EPRI (2004, 2006) Ground-Motion Model (GMM) Review Project

**Responses to NRC Review Questions
and Comments Dated July 3, 2013**

July 30, 2013

Figure 7.7.1-1
Model-to-model variability for Cluster 1

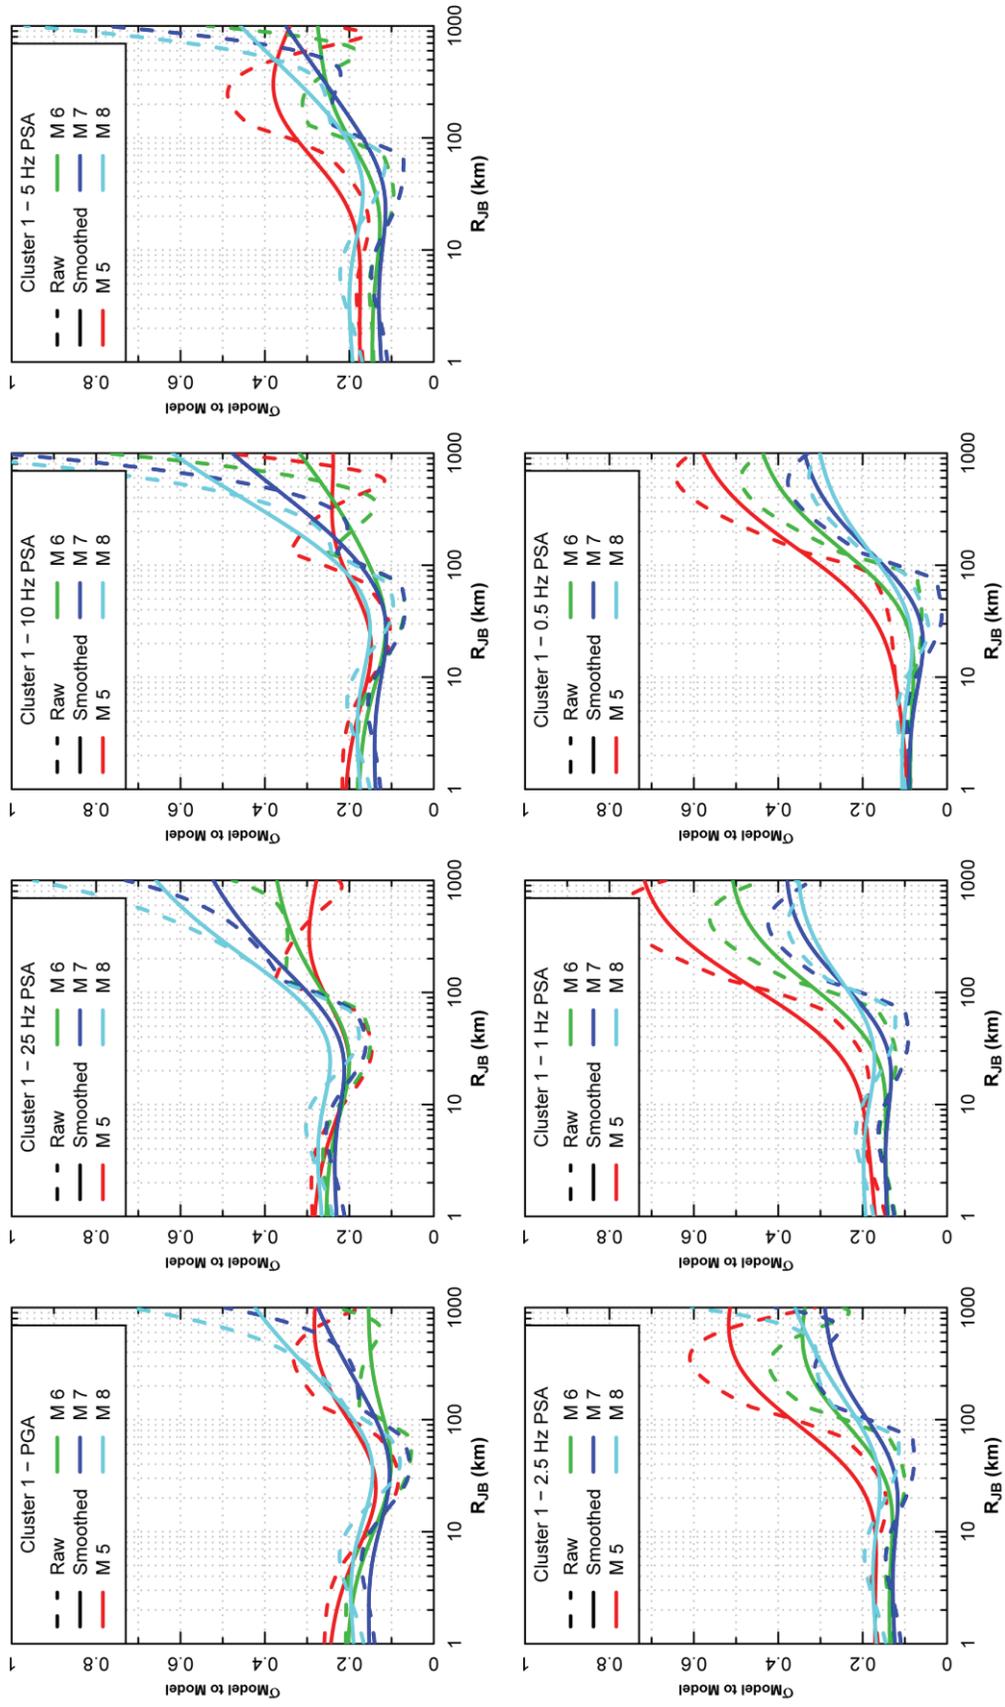
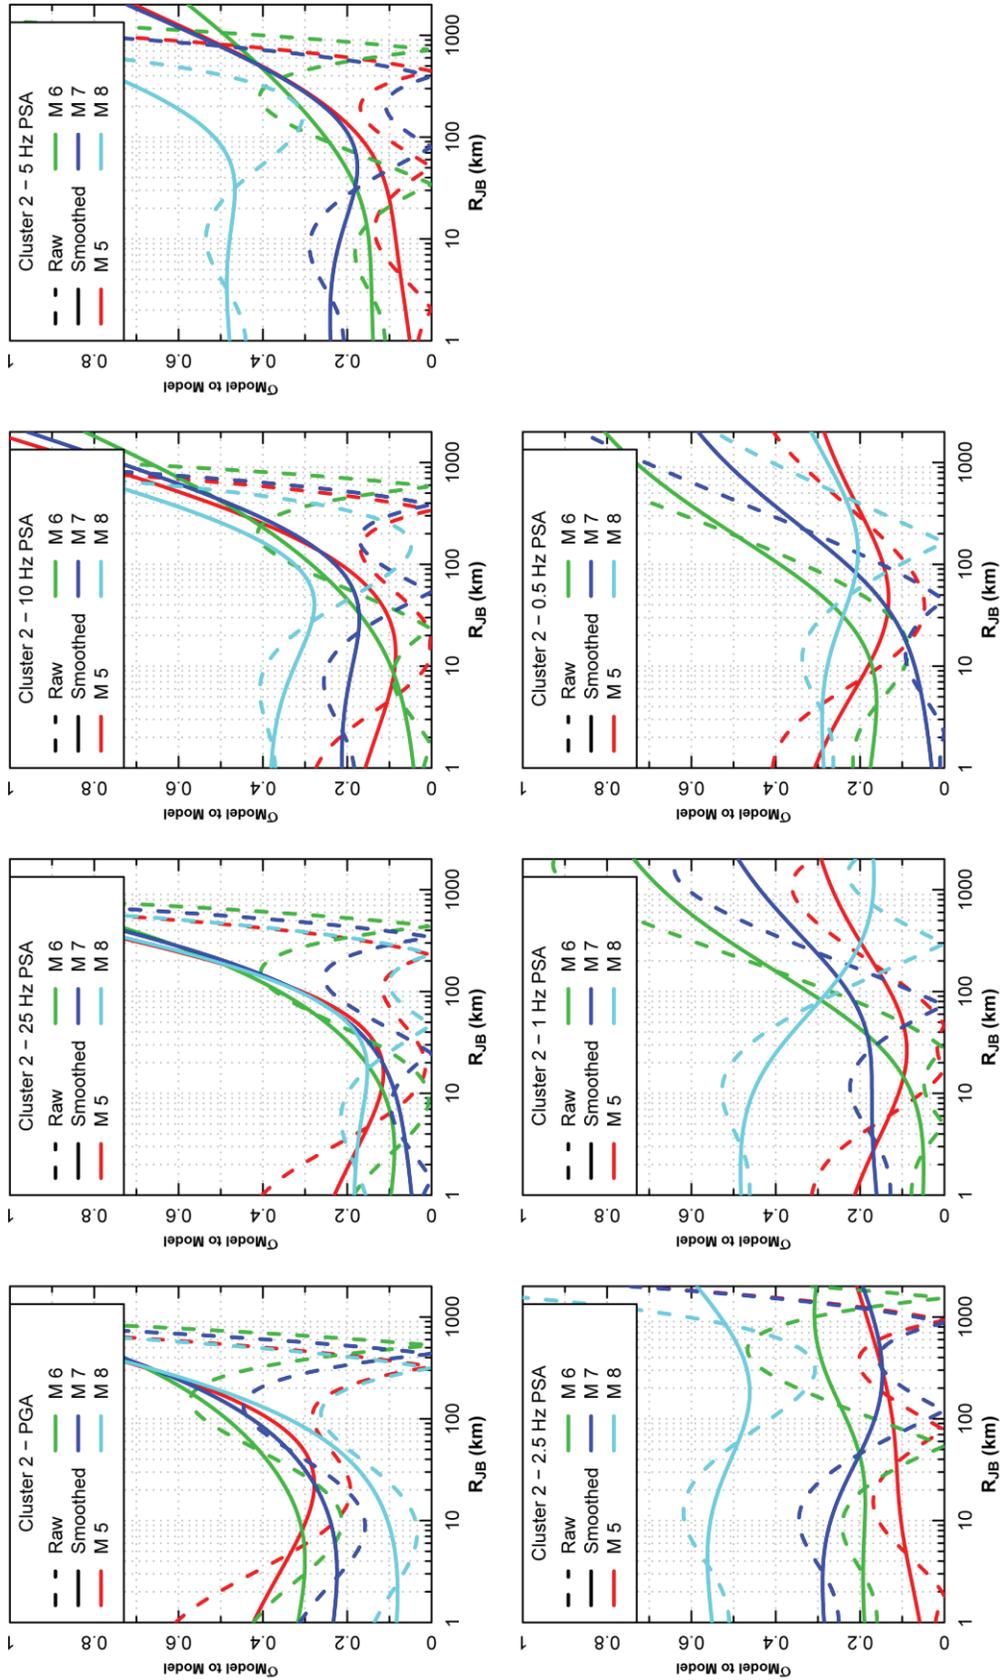
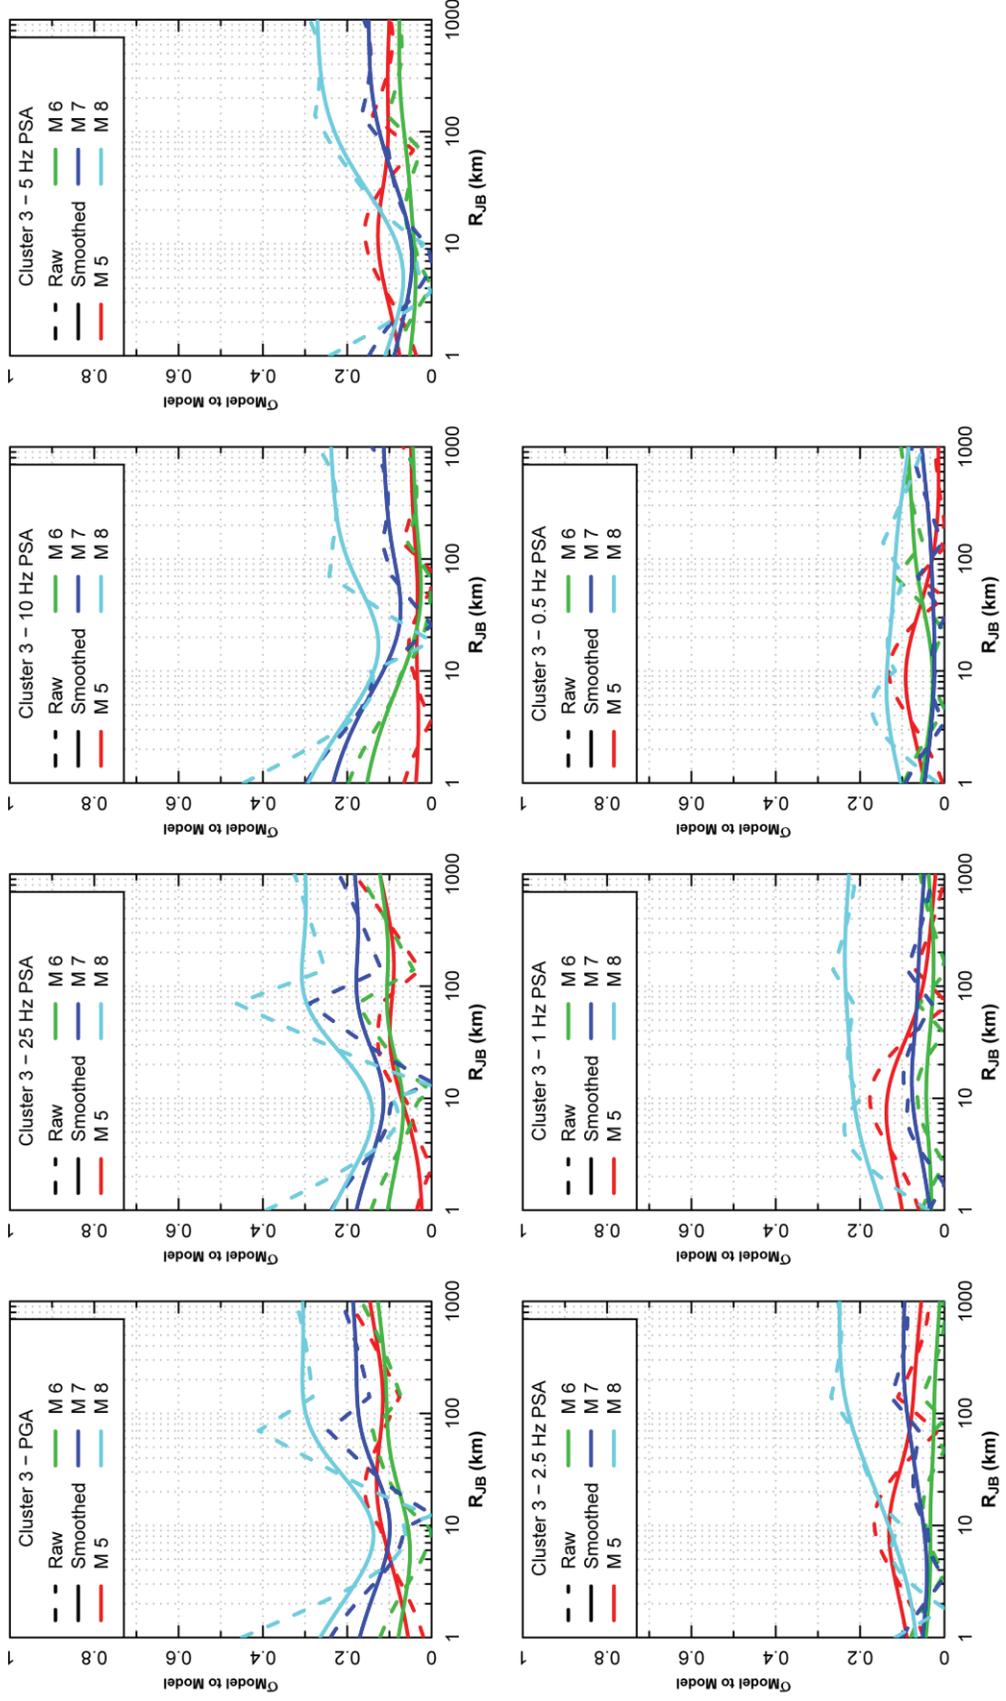
Question 7: Section 7.13 of the report provides sensitivity calculations to investigate the effects of a number of alternative assumptions. One alternative assumption that is not discussed is the overall impact of including additional uncertainty to account for magnitude scaling. Please provide a discussion of the relative importance of adding this factor, specifically with respect to the within-cluster epistemic uncertainty.

Examination of Figures 7.7.1-1 through 7.7.1-3 indicates that the within-cluster epistemic uncertainty based on model-to-model variability does not increase monotonically with magnitude for all clusters and frequencies, and a number of panels show low values (lower than 0.2 in a number of cases) for **M** 7 and 8 at distances from 1 km to 30 km.
